**KNOXVILLE/KNOX COUNTY METROPOLITAN PLANNING COMMISSION
SUBDIVISION REPORT - CONCEPT/USE ON REVIEW**

▶ **FILE #:** 1-SG-07-C **AGENDA ITEM #:** 26
1-J-07-UR **AGENDA DATE:** 1/11/2007

▶ **SUBDIVISION:** CARPENTER RIDGE, UNIT 2
▶ **APPLICANT/DEVELOPER:** EAGLE BEND REALTY
OWNER(S): EAGLE BEND REALTY

CONCEPT
PLAN
7-55-07-0
7-3-07-06

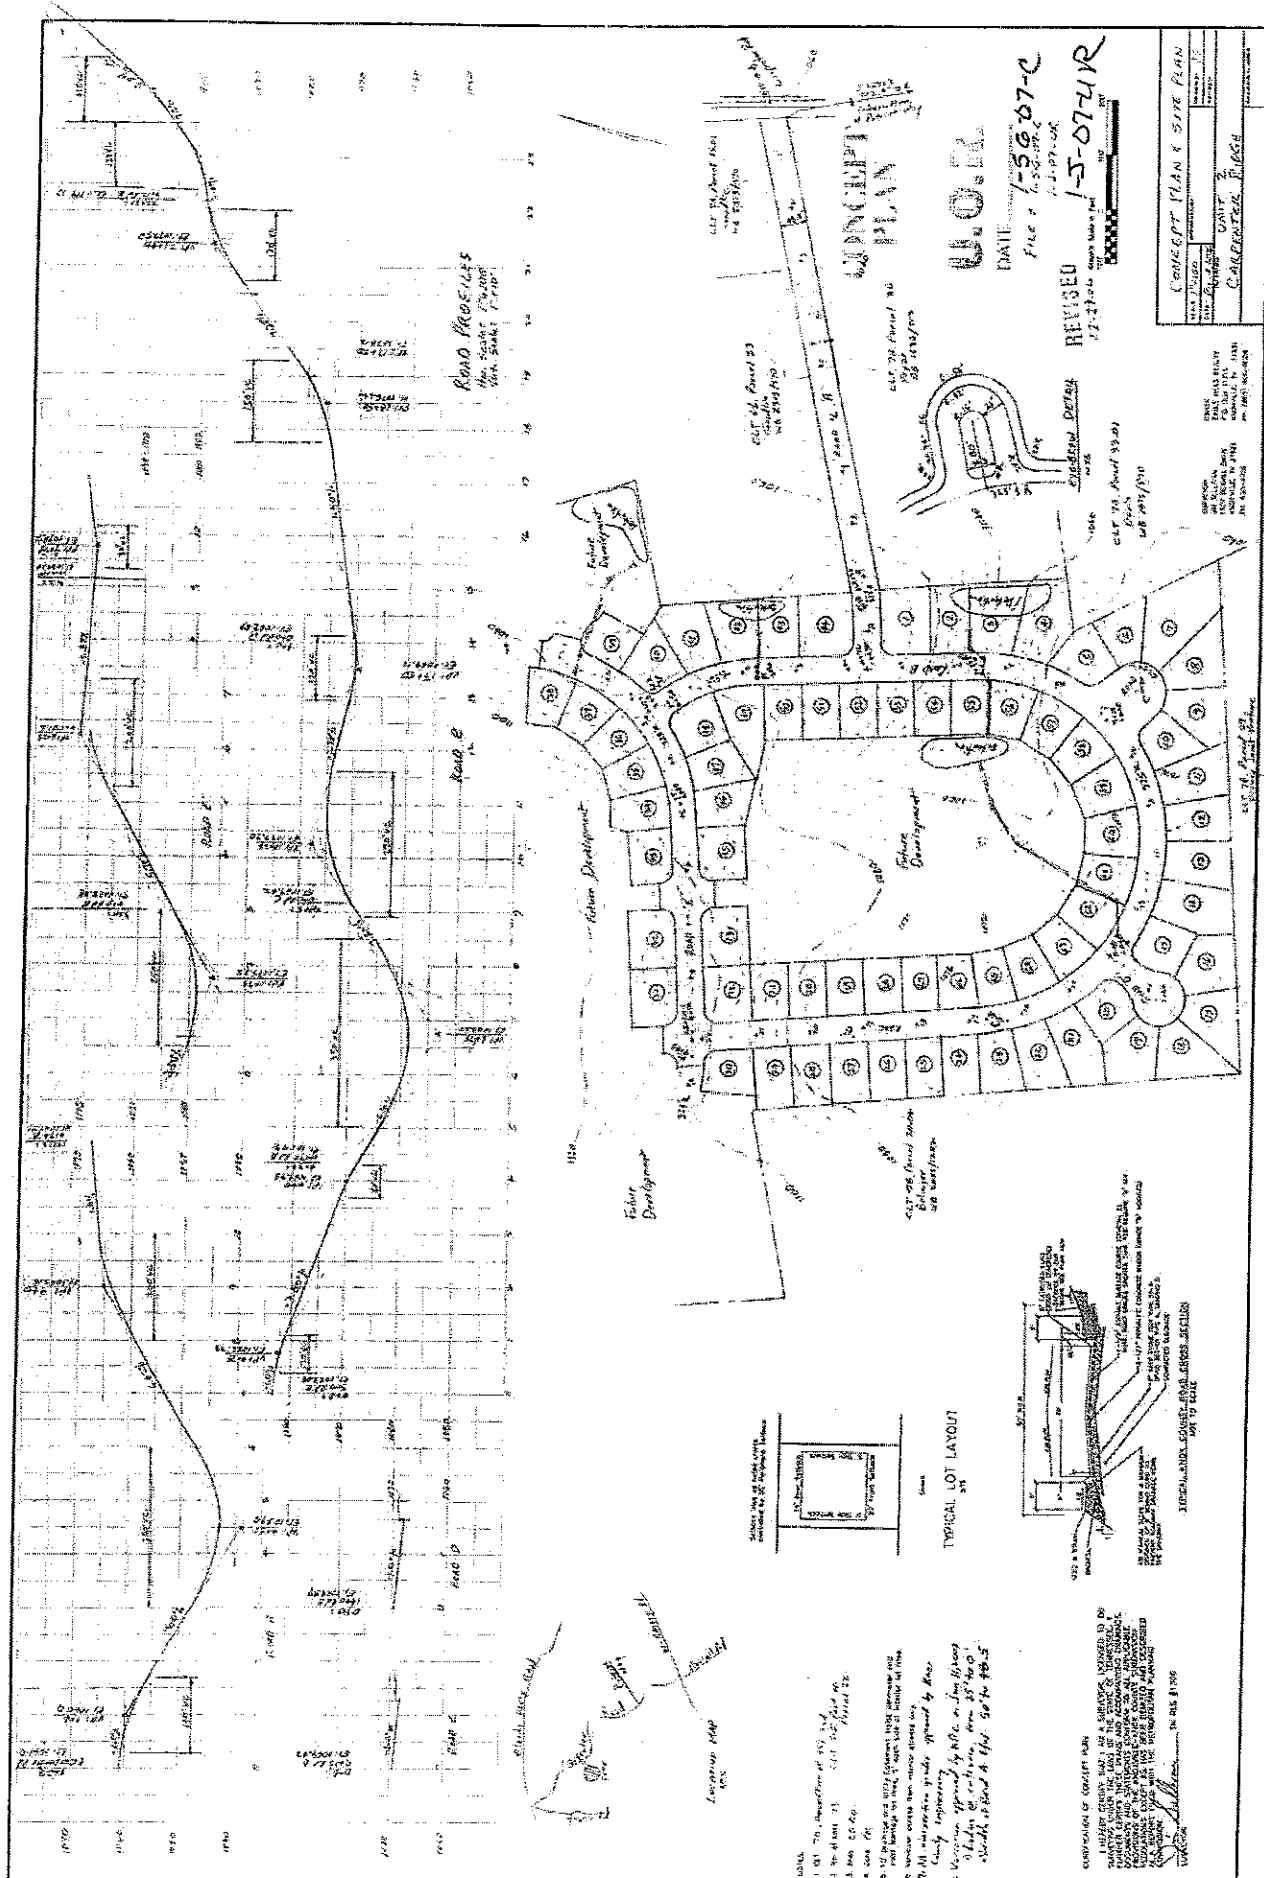
▶ **SUBDIVISION VARIANCES REQUIRED:** 1. Corner radius variances at the intersection of Road A and Carpenter Rd., from 25' to 0'.
2. Right-of-way width variance for Road A, from 50' to 48.5'.

1. Connection to sanitary sewer and meeting any other relevant requirements of the Knox County Health Department.
2. Provision of street names which are consistent with the Uniform Street Naming and Addressing System within Knox County (County Ord. 91-1-102).
3. Providing an acceptable name for the subdivision prior to submission of the final plat. Carpenter Ridge, Unit

4. Widening Carpenter Rd. to a design standard acceptable to the Knox County Department of Engineering and Public Works. Design plans for the road widening shall be submitted to the Knox County Department of Engineering and Public Works at the design plan stage of the subdivision with the improvements being made in conjunction with the road improvements for the subdivision.

5. Obtaining off-site drainage easements for the outfall from the detention basins as determined by the Knox County Department of Engineering and Public Works.

6. Providing scaled details for the design of Road C at the design plan stage of the subdivision.

8. Prior to the issuance of any grading permits for the subdivision and prior to submission of a final plat, the applicant shall establish at least 300' of sight distance at the subdivision entrance onto Carpenter Rd. The required sight distance shall be certified in the field. (See comment section below)

On visiting the site it appeared that sight distance to the north along Carpenter Rd. at the subdivision entrance was limited. Staff requested that the applicant's surveyor perform an instrument certification of the site distance on site. Along the edge of pavement he could only certify 260' of sight distance. At the required 15' setback from the edge of pavement it was much less. The required sight distance at this location is 300'. The limited sight distance is due to a hump in the road and roadside embankment. Due to safety concerns with the limited sight distance and number of lots proposed in the subdivision, staff cannot recommend approval of the subdivision if the sight distance cannot be provided. By grading down the hump in the roadway and roadside banks it may be possible to obtain the sight distance. Staff is recommending a condition that prior to the issuance of any grading permits for the subdivision and prior to submission of a final plat, the applicant shall establish at least 300' of sight distance at the subdivision entrance onto Carpenter Rd. During the design plan stage of the development, the applicant will submit plans to the Knox County Department of Engineering and Public Works for the work in the public right-of-way. Once the permit is issued the applicant shall make the necessary improvements to achieve the required sight distance. The required sight distance shall be certified in the field before any additional permits will be issued for the subdivision or a final plat is accepted for review.

The Planning Commission and Knox County Engineering Staff are also recommending that Carpenter Rd. be widened from the area of the road improvements for obtaining sight distance north of the entrance, south to the improvements on Carpenter Rd. that were implemented as part of the Carpenter Ridge Subdivision.

▶ **APPROVE** variances 1 and 2 because the existing access strip for the property restricts compliance with the Subdivision Regulations, and the proposed variances will not create a traffic hazard.
